SUBJECT: Forwards revised response to Question 410.48 re associated circuits. Response will be incorporated into FSAR in future amend.

Re: St. Lucie Unit No. 2
Docket No. 50-389
Final Safety Analysis Report
Response to ASB Question 410.48

FLORIDA POWER & LIGHT COMPANY
ST. LUCIE NO. 2

ASSOCIATED CABLES

FIG-2C

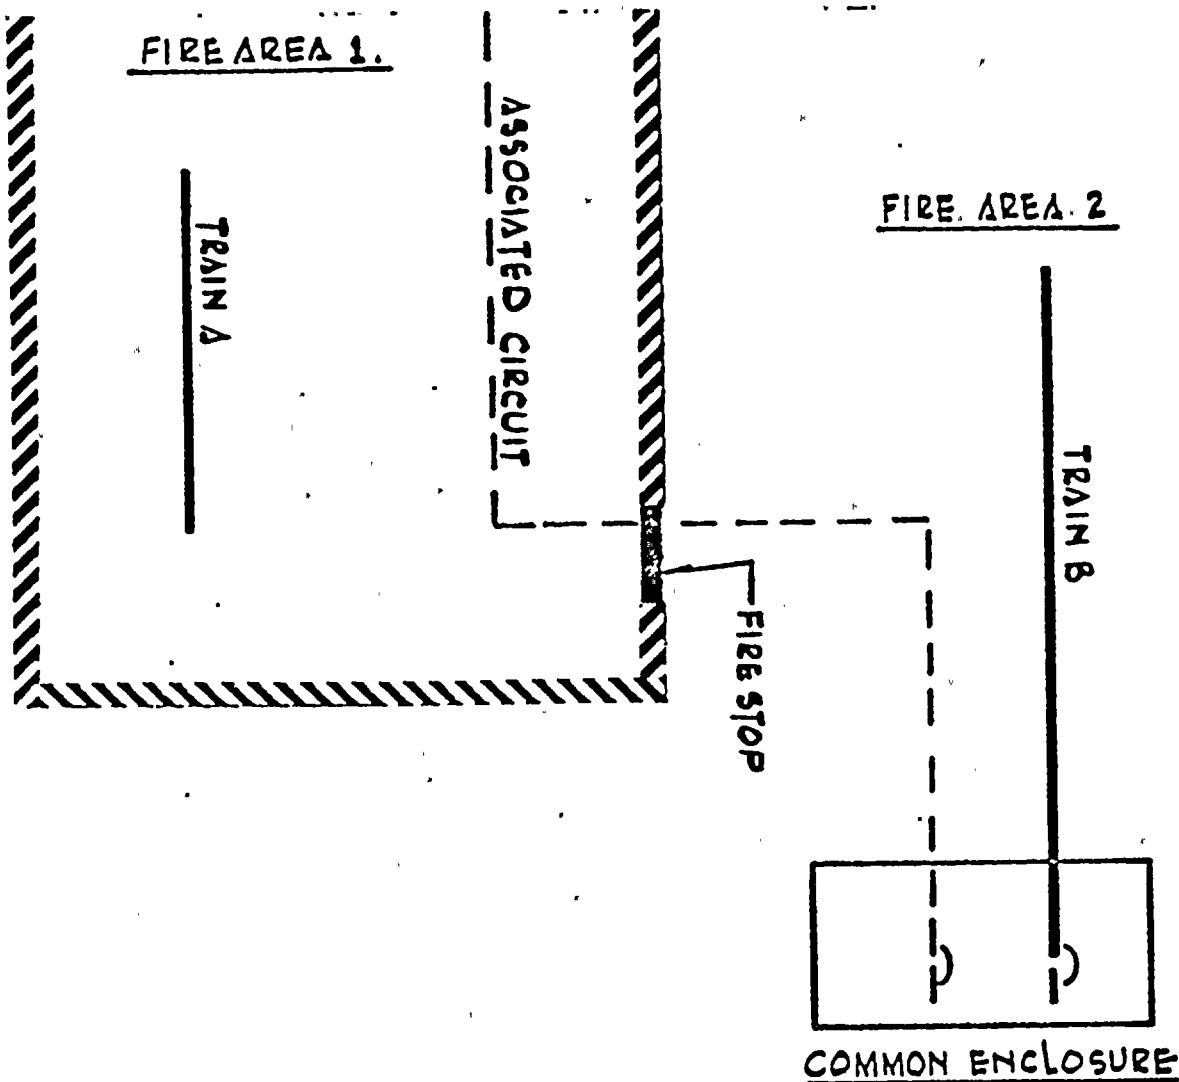
410.48 The documentation on associated circuits is incomplete. Enclosed is a staff position regarding associated circuits entitled "Associated Circuit Guidance. Using the staff position, provide a discussion of associated circuits which identifies each associated circuit and the means to protect these circuits for every fire area. A fire area is an area which is surrounded by three hour rated fire barriers, including floors, ceilings, floor to ceiling walls, and all penetrations.

For all circuits that do not meet the separation criteria of section III.G.2 of Appendix "R" and have a common enclosure, propagation of a fire into the common enclosure (see figure 2c attached) is prevented by the provision of fire stops at all fire boundries and by the use of IEEE-383 qualified cable which will not propagate fire. In addition all circuits are protected by circuit breakers or fuses. Therefore, all circuits are excluded from the staff's definition of associated circuits as outlined above in item 2c. Three examples of non-essential components whose circuitry shares a common enclosure (MCC-2A5) with essential equipment are shown on CWDs 167, 270 and 522. Protection of the essential components is provided by circuit breakers and thermal overloads.

A FIRE IN FIRE AREA 1 WILL NOT AFFECT THE TRAIN B CABLES IN THE COMMON ENCLOSURE BECAUSE THE FIRE WILL NOT PROPAGATE INTO FIRE AREA 2 BECAUSE CABLES ARE FIRE RETARDANT AND A 3HR. FIRE BARRIER IS PLACED IN THE TRAY WHERE THE CABLE PENETRATES THE WALL.
